Interactive comment on “The open boundary equation” by D. Diederer et al.

D. Diederer et al.

Received and published: 13 October 2015

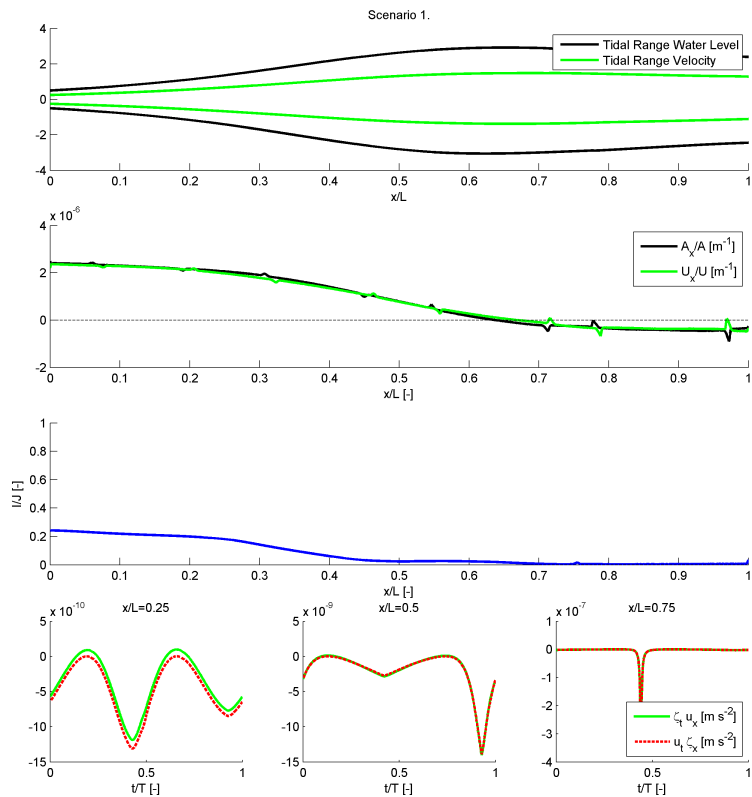
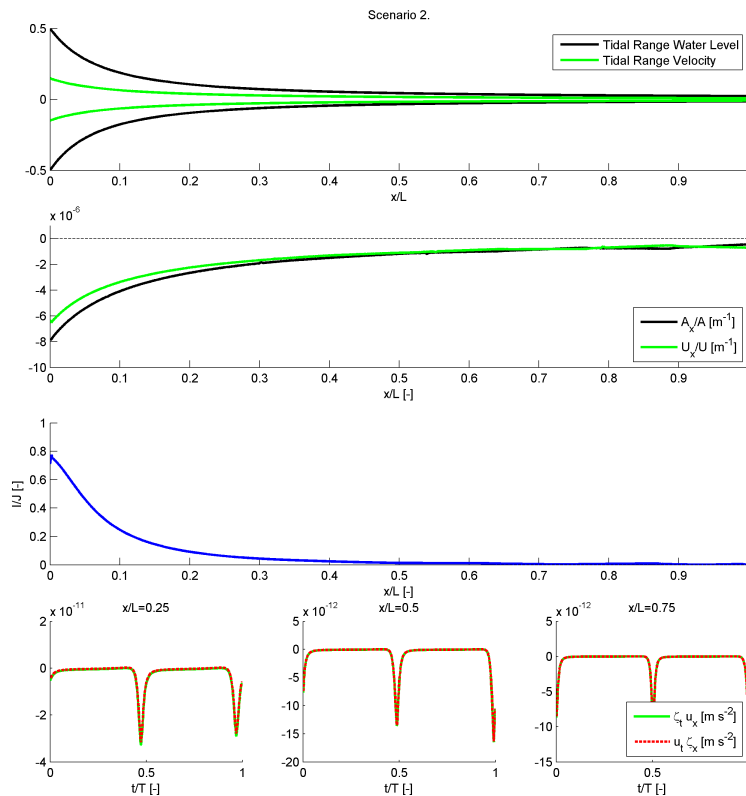
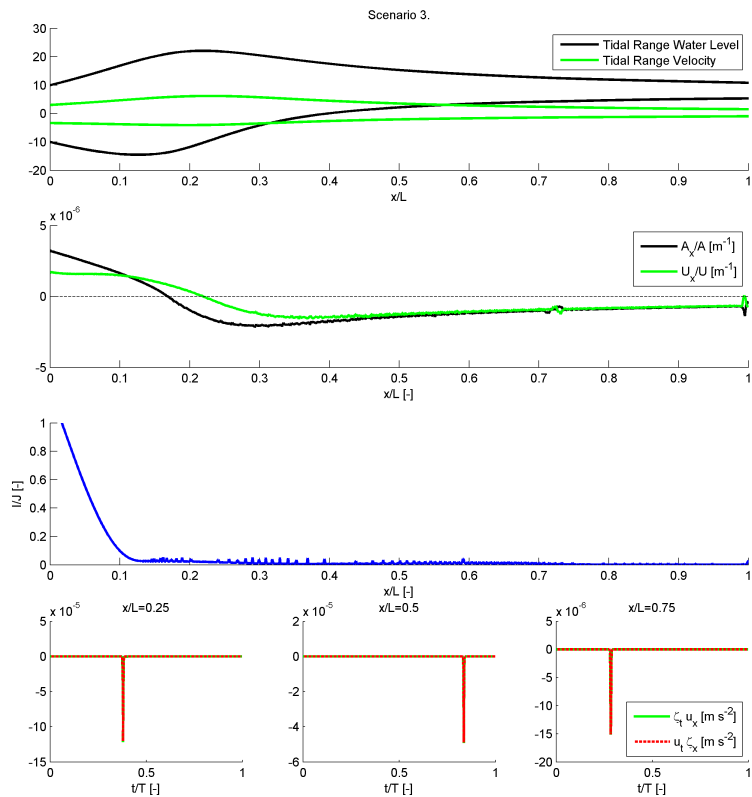
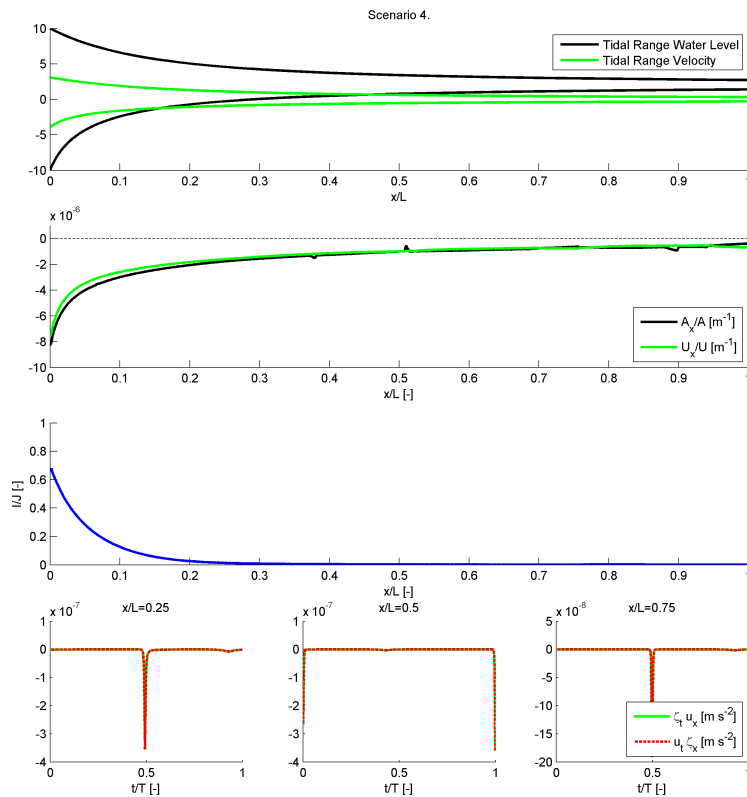
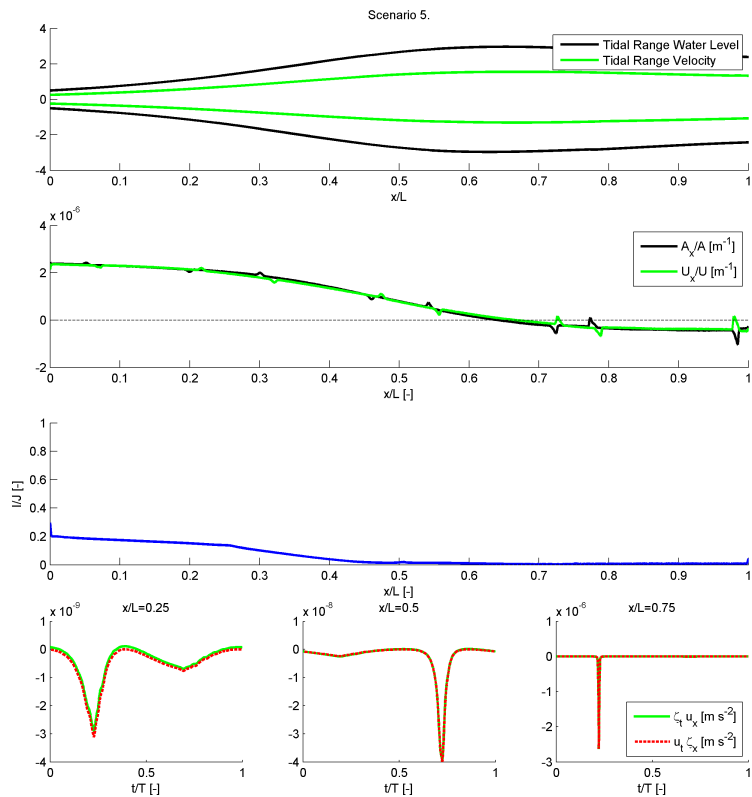
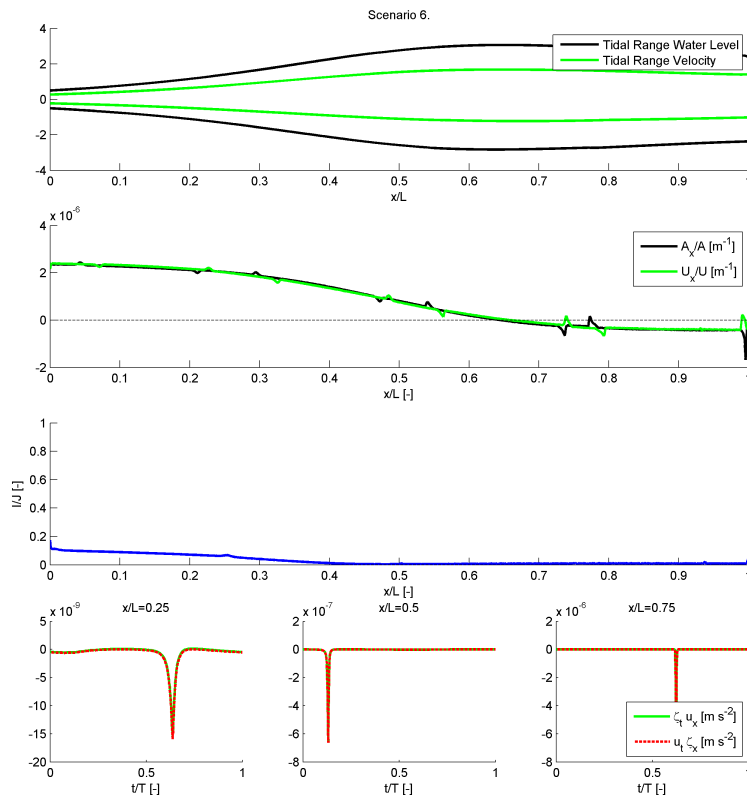
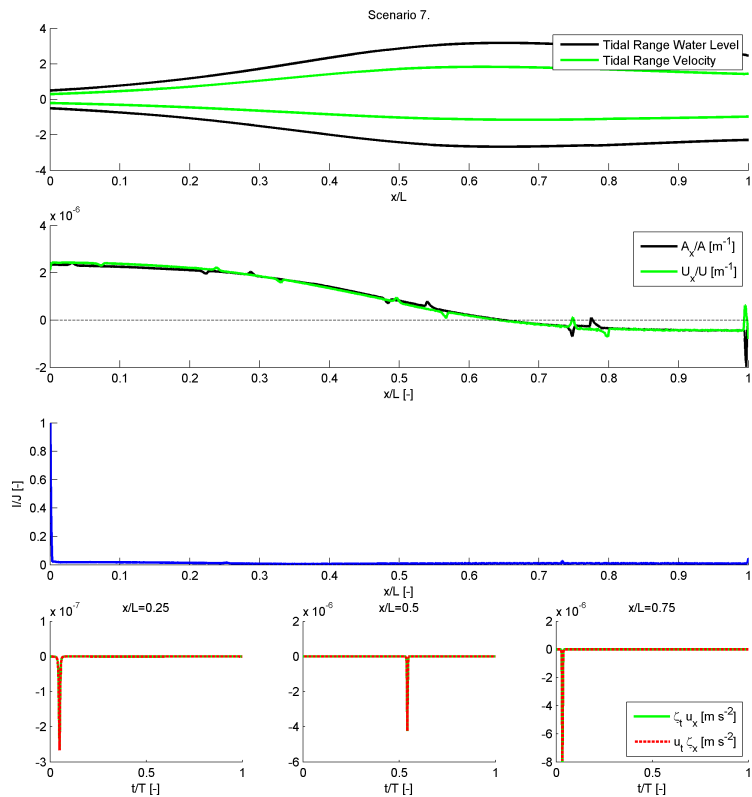
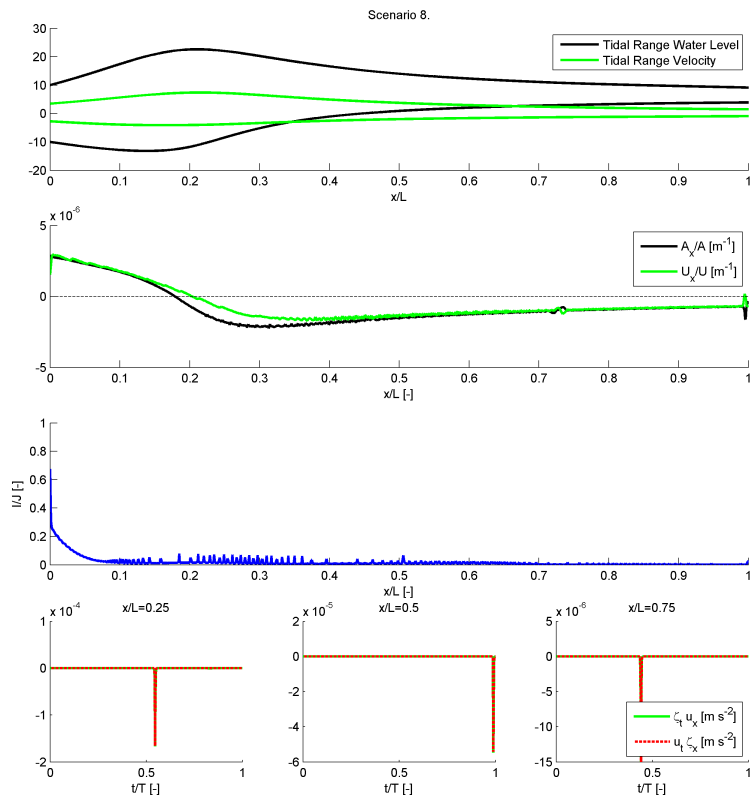
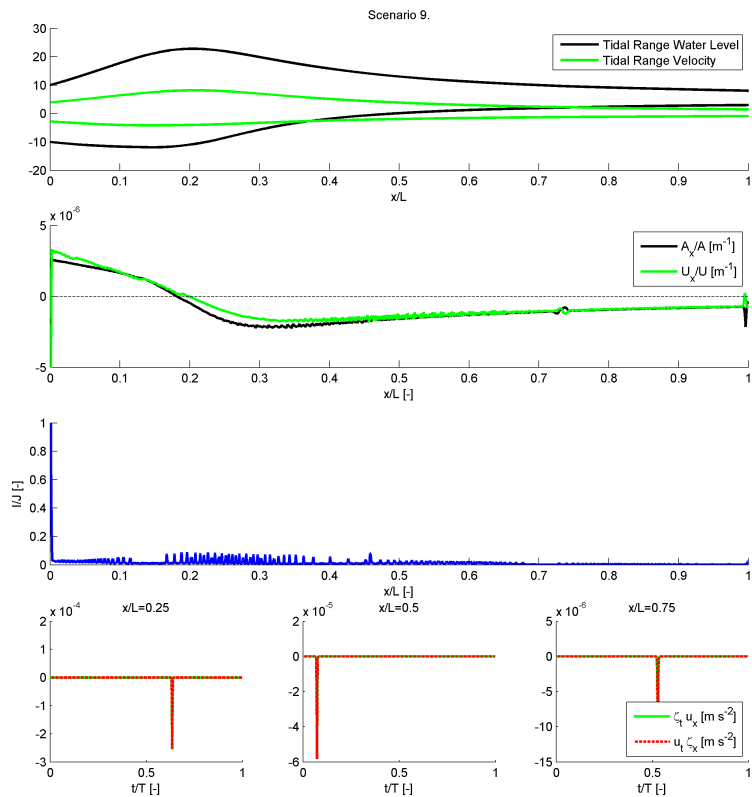
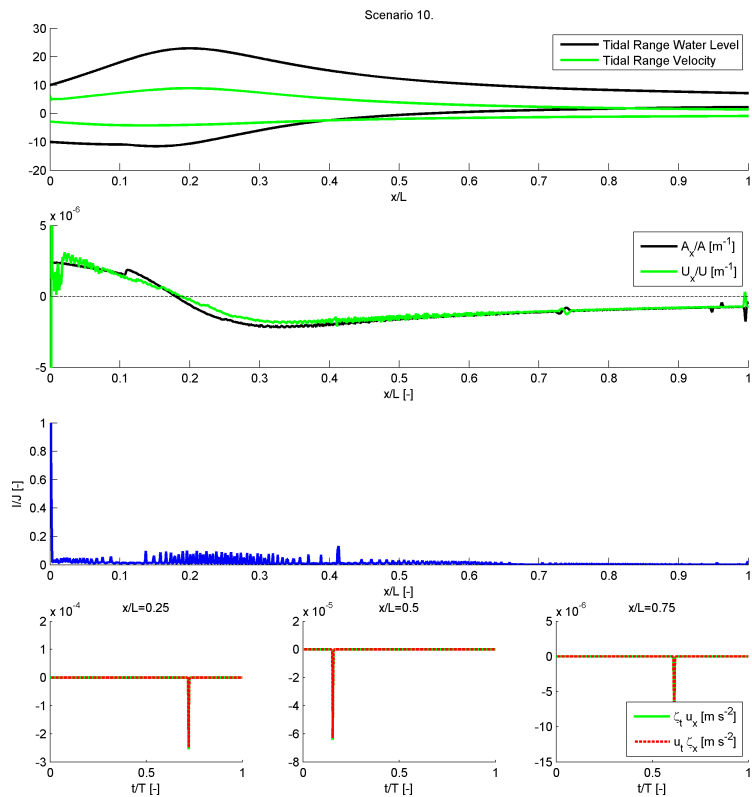
We do agree with Referee #2 that near the downstream boundary the deviation is not small, which can be observed in the correlation plots of I/J (see Figs. (1-10)). However, we will demonstrate in Sect 4.2 that these deviations are caused by the imposed boundary, which does not satisfy (22). If a boundary condition is chosen that does approximately satisfy (22), then the deviations become very small.

1. we have studied more scenarios (see Table 1 and Figs. 1-10),
2. we have compared the correlation I/J to the amplification/damping A_x/A and U_x/U where

and b is the convergence length of the width. We have compared ψb (see Table 1) to the length scale of adjustment in the correlation plots I/J (see Figs. 1-10).

The correlation plots of I/J have in common that they show a trend towards better performance farther from the seaward boundary. This applies for the all scenarios, amplified or damped.

If Eq. (22) would specifically apply for the case where the amplitudes remain constant, as in the first case of the appendix of the manuscript, the optimal performance of I/J should be around the location where the switch from amplification to damping occurs, i.e. where A_x/A and U_x/U are zero. In Scenario #1 this location lies around $x = 0.65L$, and in Scenario #3 this location lies around $x = 0.2L$. Instead of an optimal performance, the correlation I/J shows improving performance landward of this location. The seaward boundary effect is clearly present in these scenarios, especially in the amplified scenarios 1 and 3, allowing some room for doubt.

The values of ψb are presented for the 8 scenarios which show amplification and damping in Table 1. When comparing ψb to the length scale of adjustment of the seaward boundary effect in the correlation plots I/J in Fig. 1-10, we observe that ψb is an order of magnitude larger. This comparison confirms that the ‘adjustment length’ of the seaward boundary effect is not related with the convergence (which is present in the entire domain) nor with an equilibrium between damping and amplification.

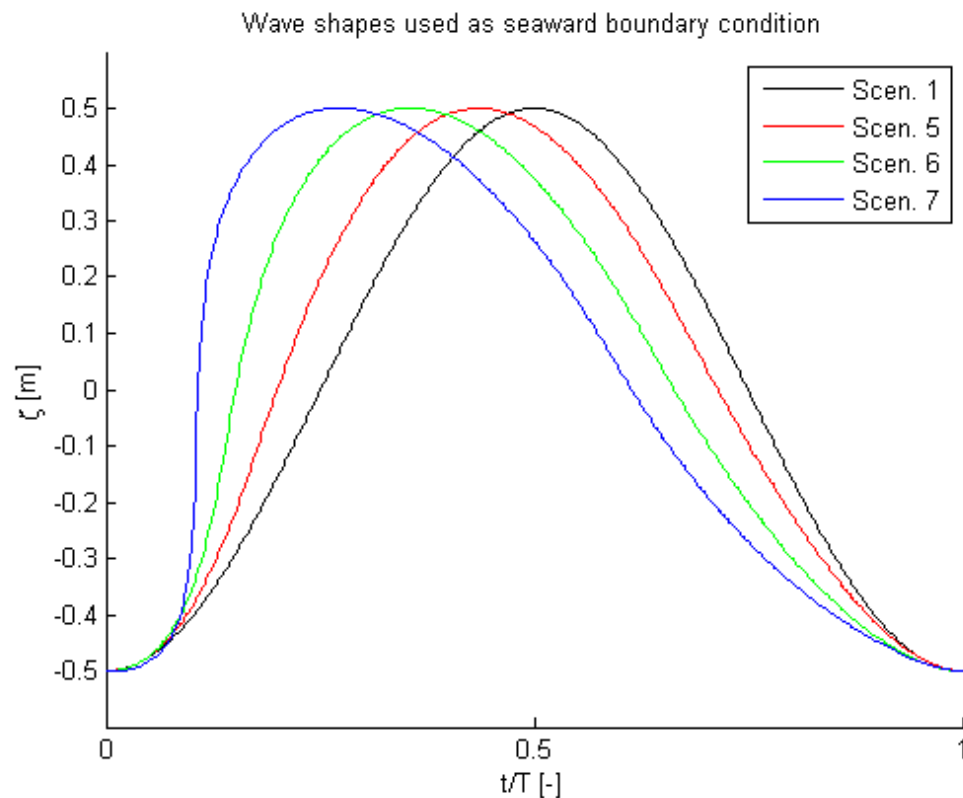
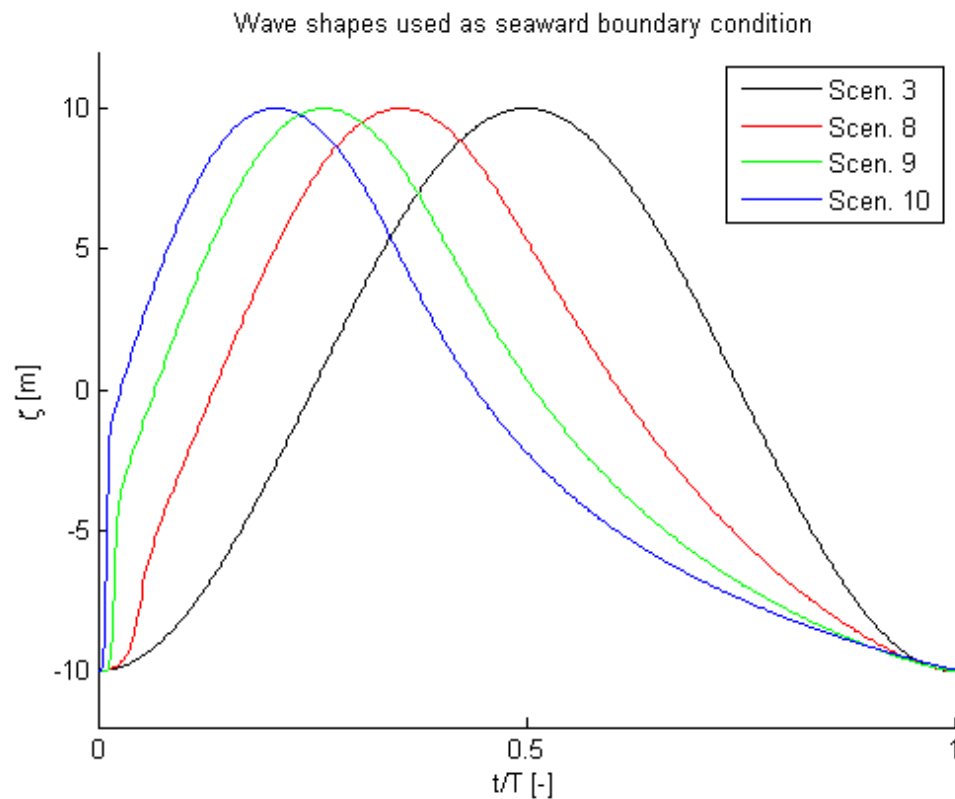
$$A(x) = \frac{\max(\zeta) - \min(\zeta)}{2}, U(x) = \frac{\max(u) - \min(u)}{2},$$
3. we show time series of $\zeta_t u_x$ versus $u_t \zeta_x$ on several locations in the estuaries,
4. we have studied additional experimental scenarios 5-10, where we imposed a tidal wave on the downstream boundary with the same tidal range as in scenarios 1 and 3, but with the shape of the tidal wave at a location farther in the estuary (see Figs. 11-12)

More clear are the scenarios where a nonlinear shape of the water level was imposed as a seaward forcing boundary condition. The seaward boundary effect has almost

entirely disappeared in scenarios (7,9,10), even though the tidal ranges still show a clear amplification and damping. So for scenarios (7,9,10), there is no boundary effect and the OBE applies in the full reach.

Interestingly, scenarios (9,10) also show a relative damping of the velocity and the tidal amplitude that is almost the same, whereas this is not the case if a pure sinus is imposed at the downstream boundary.
